Addendum #01

Date: June 25, 2021

Project: Huntington Middle School Modernization and Addition

1A GYM - N
SCALE: 1/4" = 1'-0"

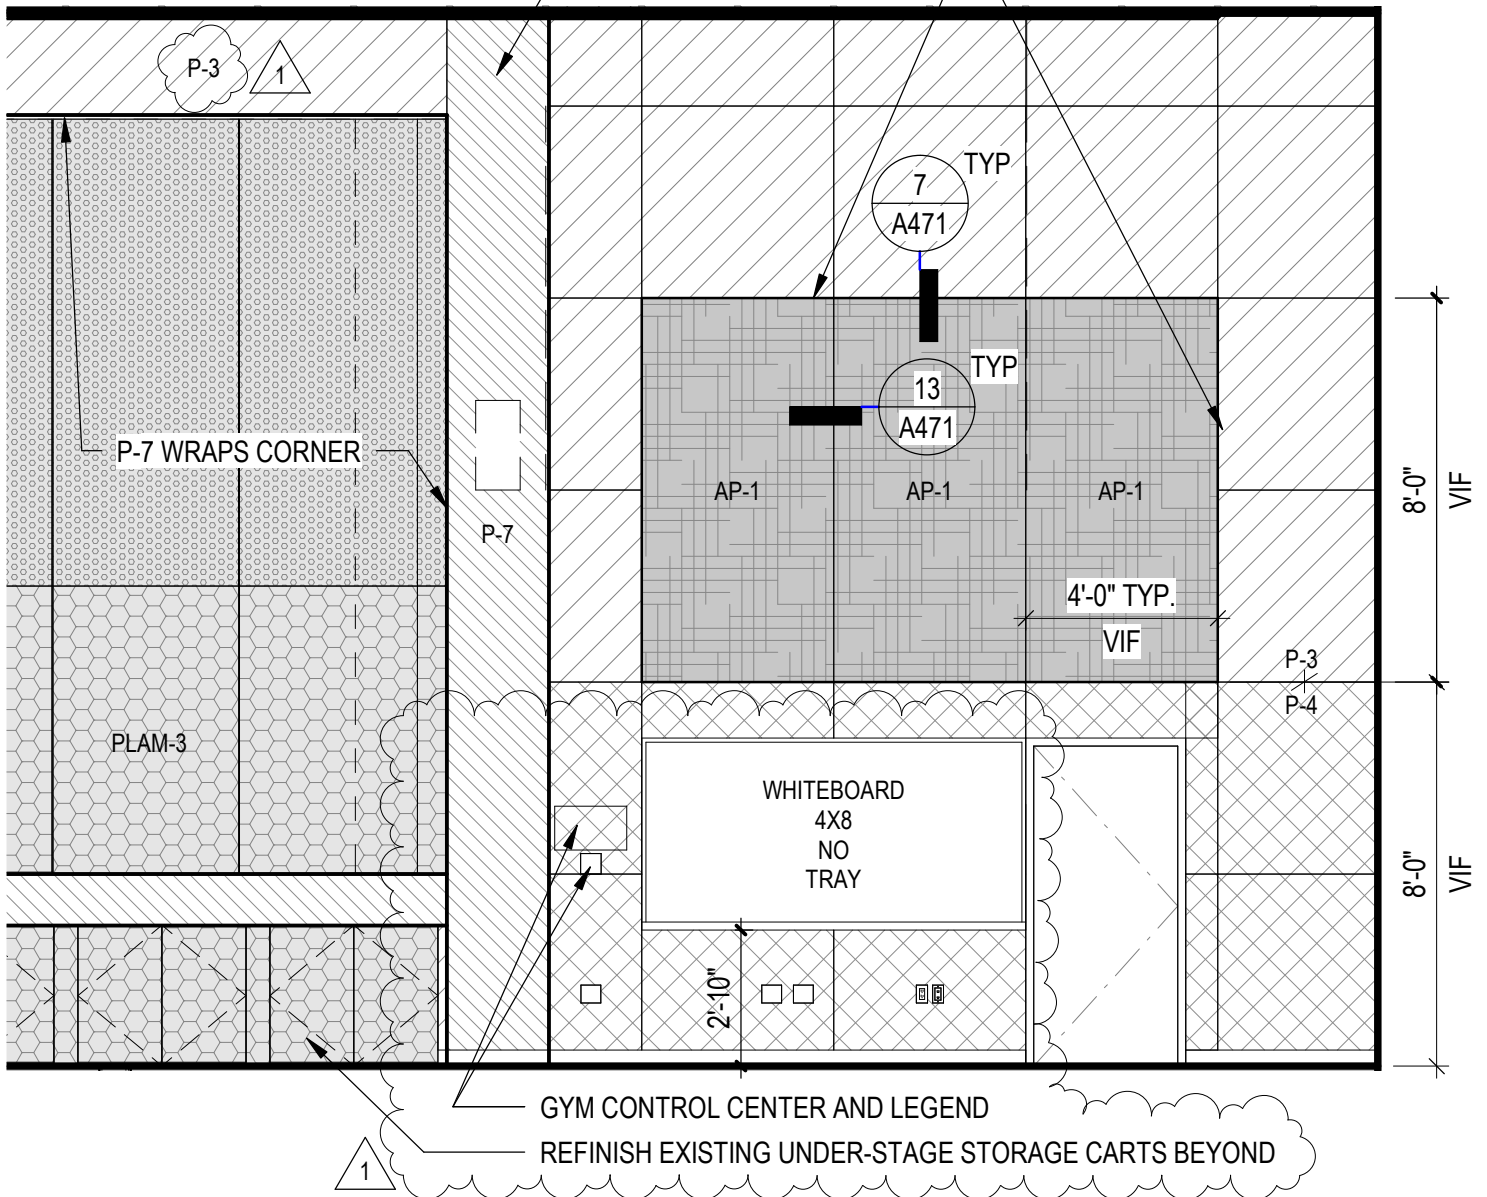
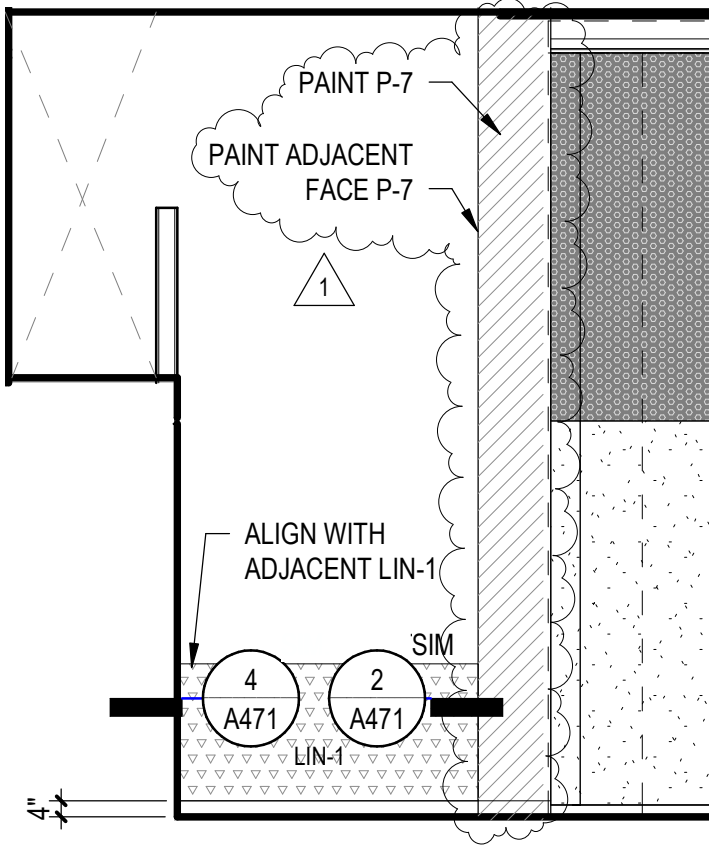
Item #A04 A451 – INTERIOR ELEVATIONS - PUBLIC
Add. #01 **Revise** 1A/A451 per attached **ADA 001**

1C AUX GYM - S
SCALE: 1/4" = 1'-0"

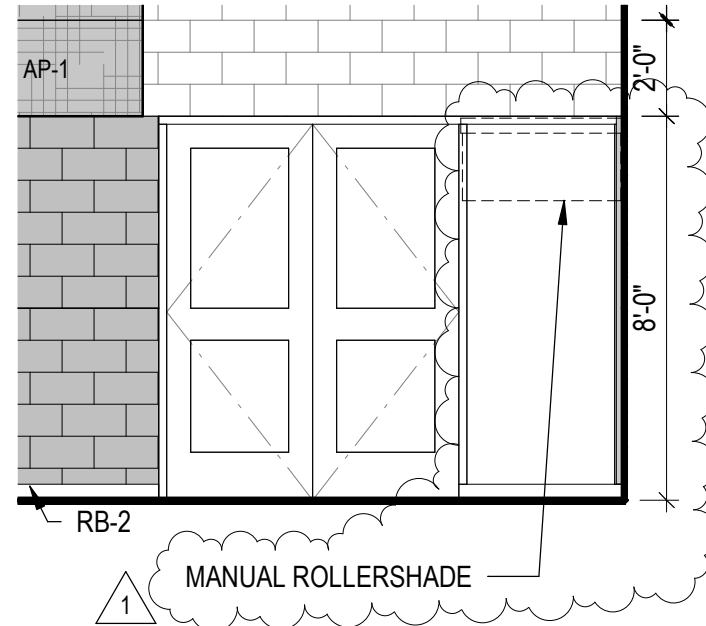
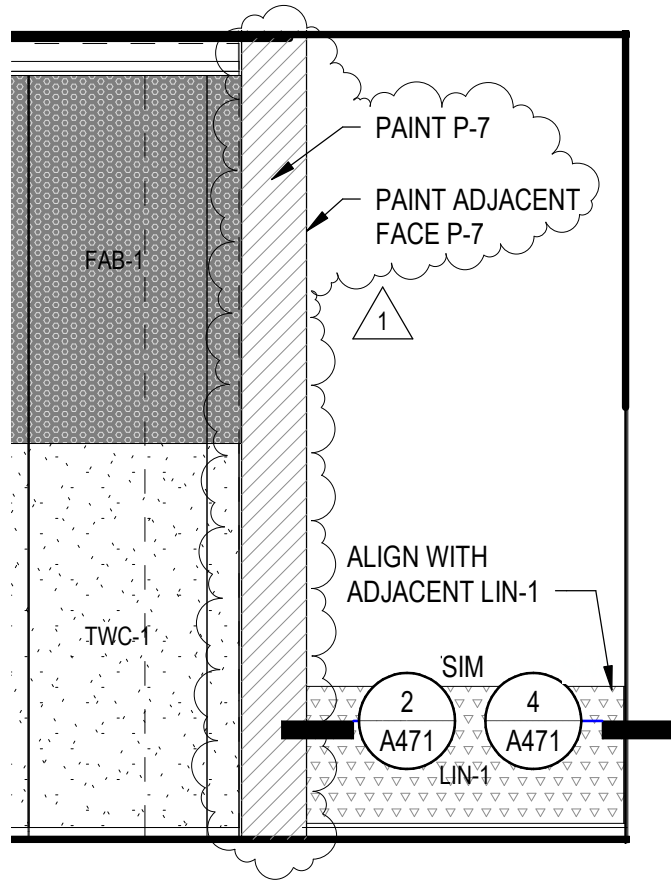
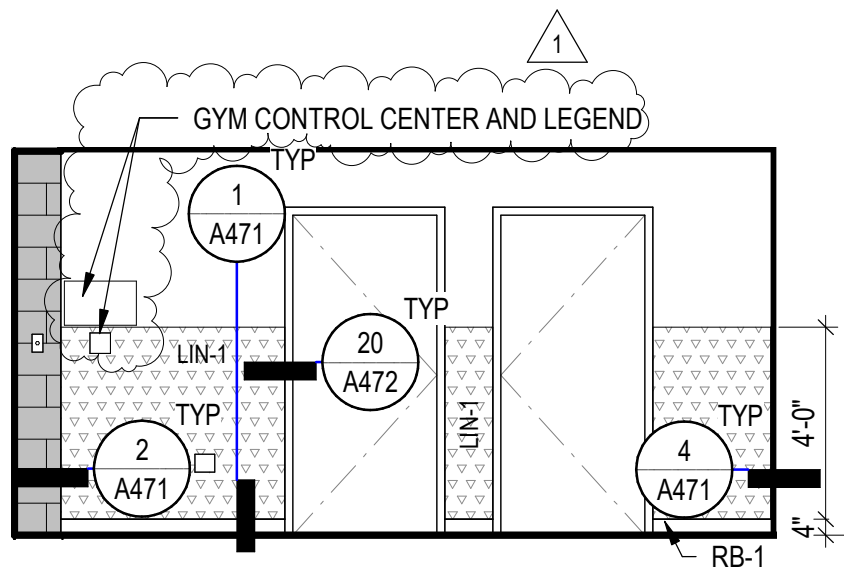
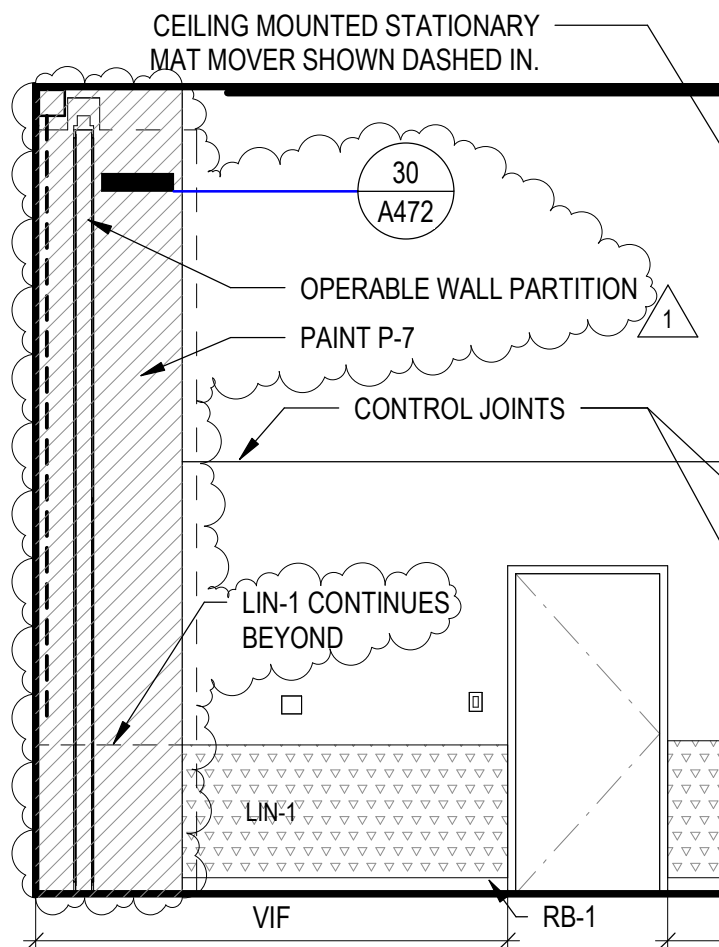
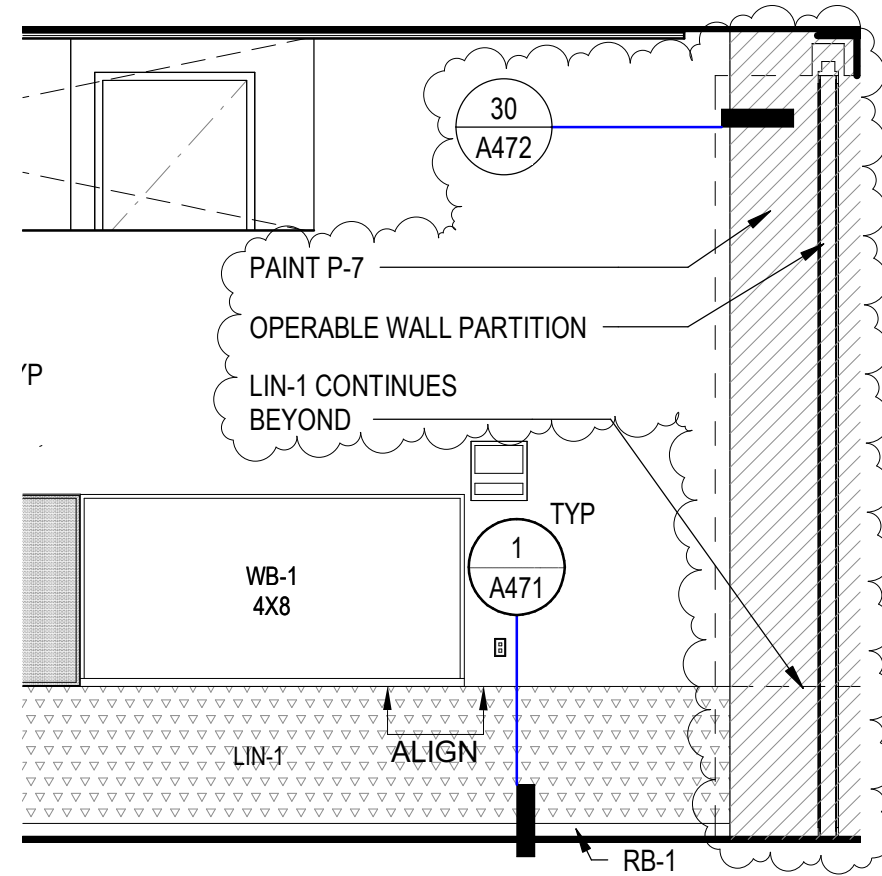
Item #A05 A452 – INTERIOR ELEVATIONS - PUBLIC
Add. #01 **Revise** 1C/A452 per attached **ADA 002**

Revise 2B/A452 per attached **ADA 002**

Revise 2C/A452 per attached **ADA 002**

Revise 2D/A452 per attached **ADA 002**

Revise 3C/A452 per attached **ADA 002**

1A FCS - W
SCALE: 1/4" = 1'-0"

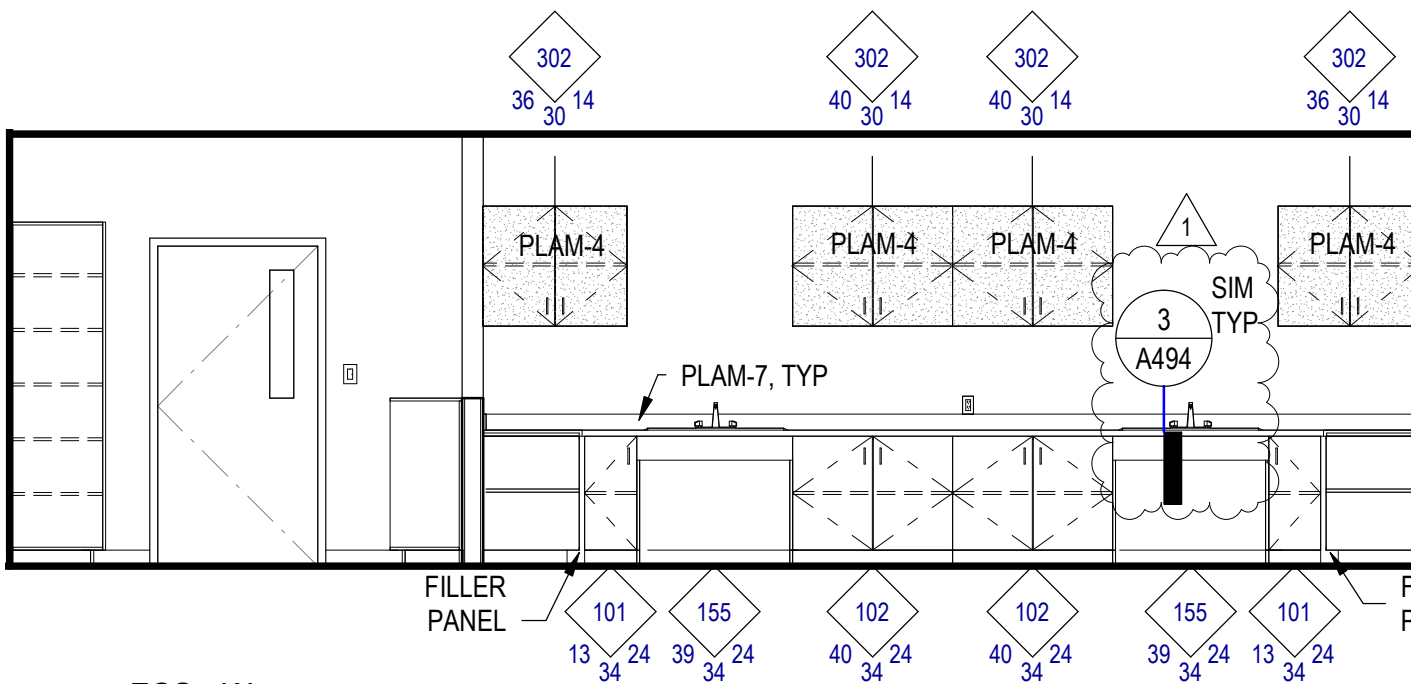
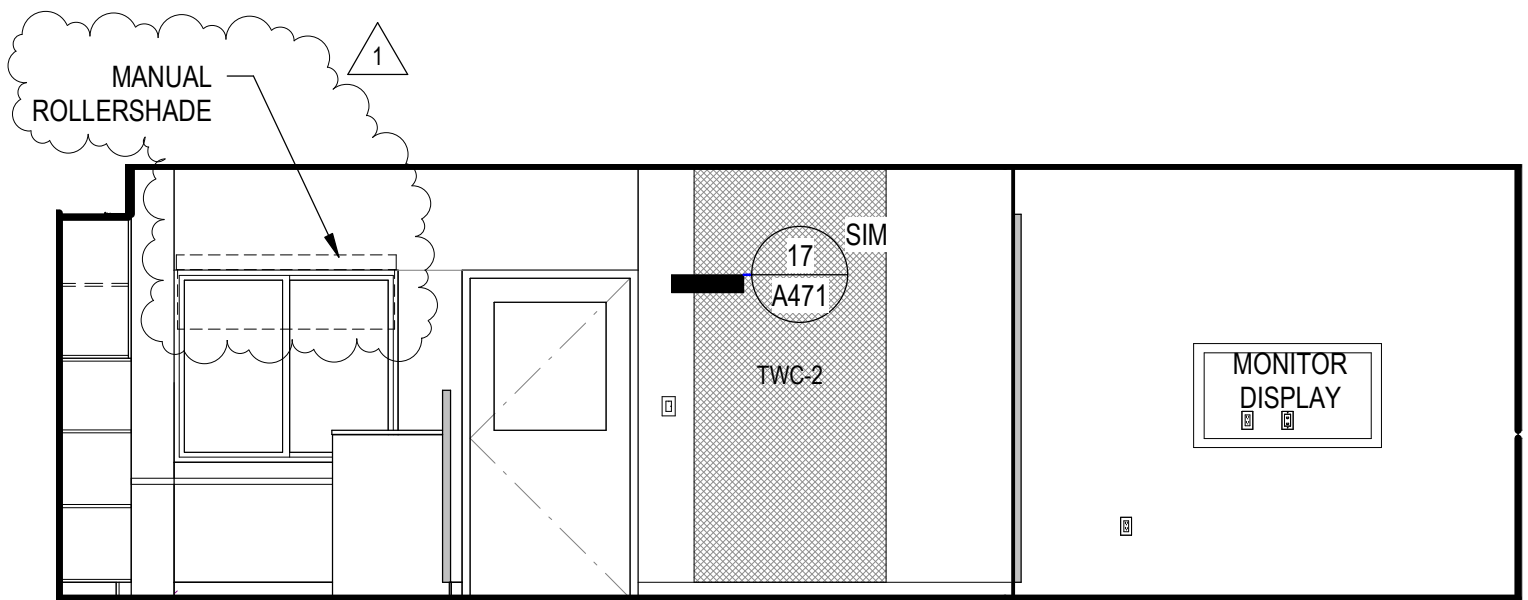
Item #A06 A460 – INTERIOR ELEVATIONS - LEARNING SPACES
Add. #01 **Revise** 1A/A460 per attached **ADA 003**

A461

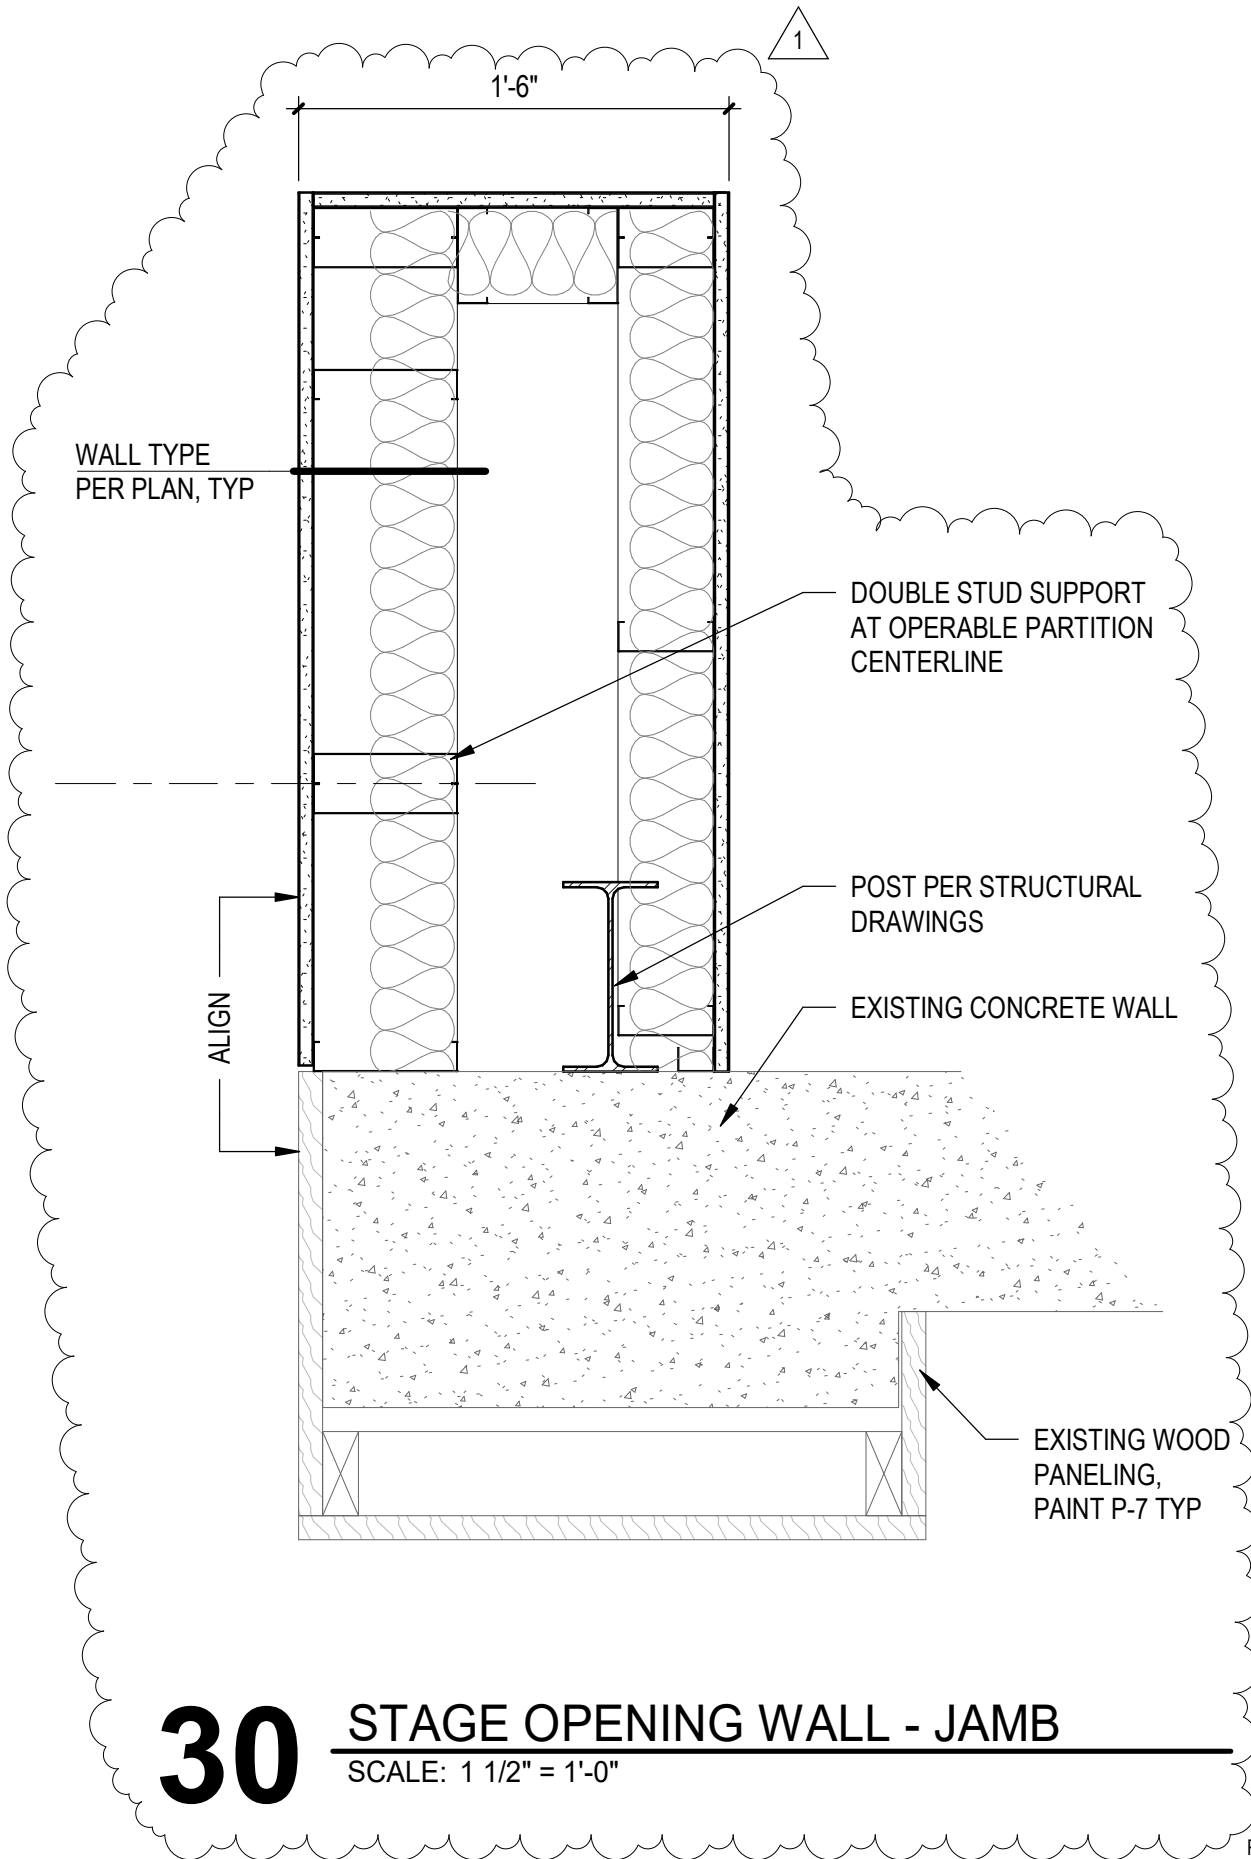
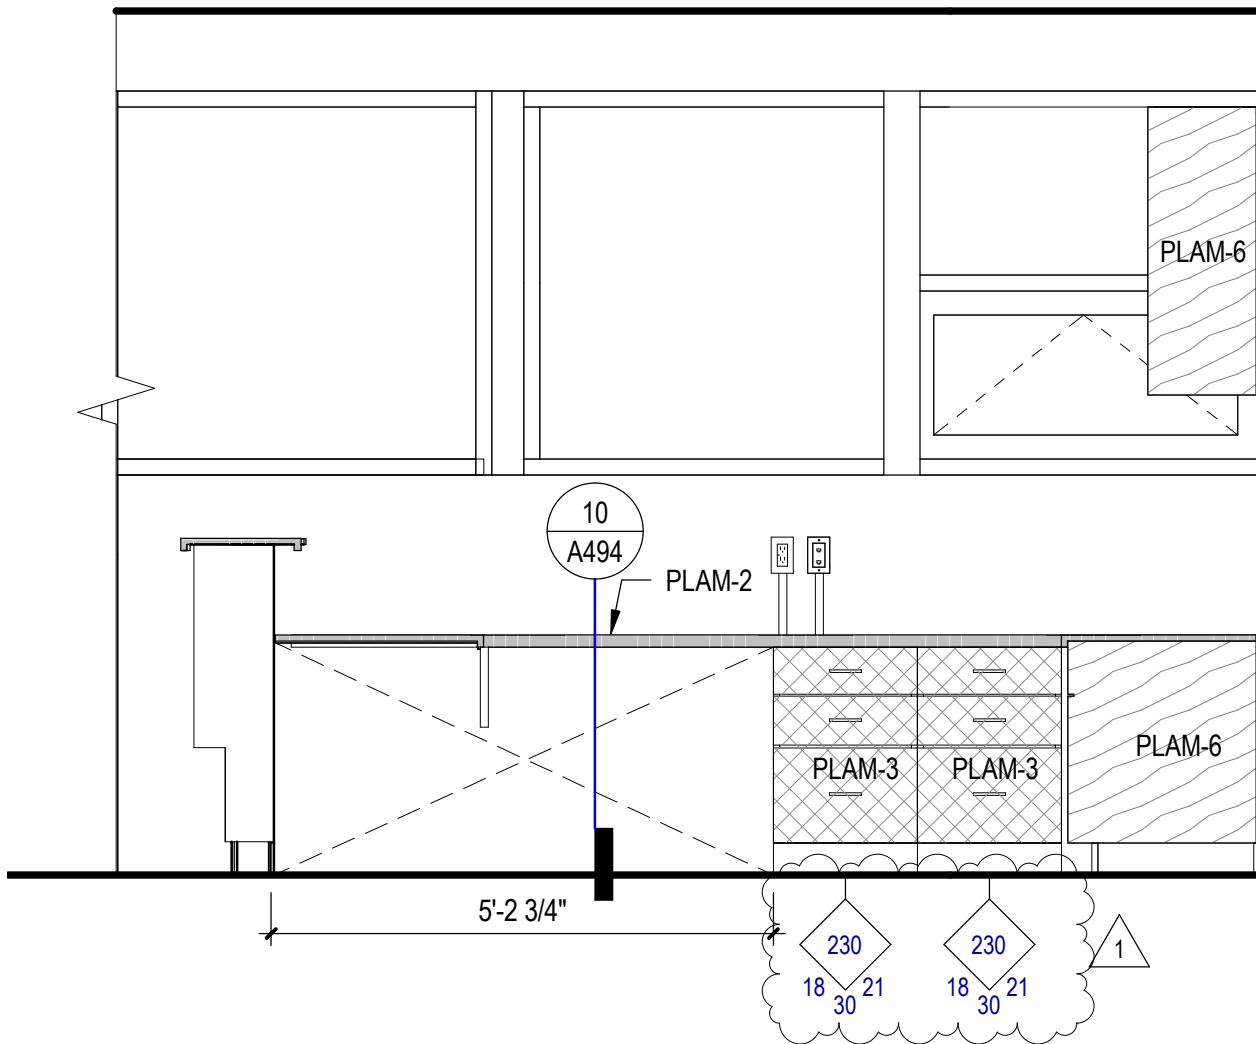
Item #A07 A461 – INTERIOR ELEVATIONS - ADMIN
Add. #01 **Revise** 1A/A461 per attached **ADA 004**
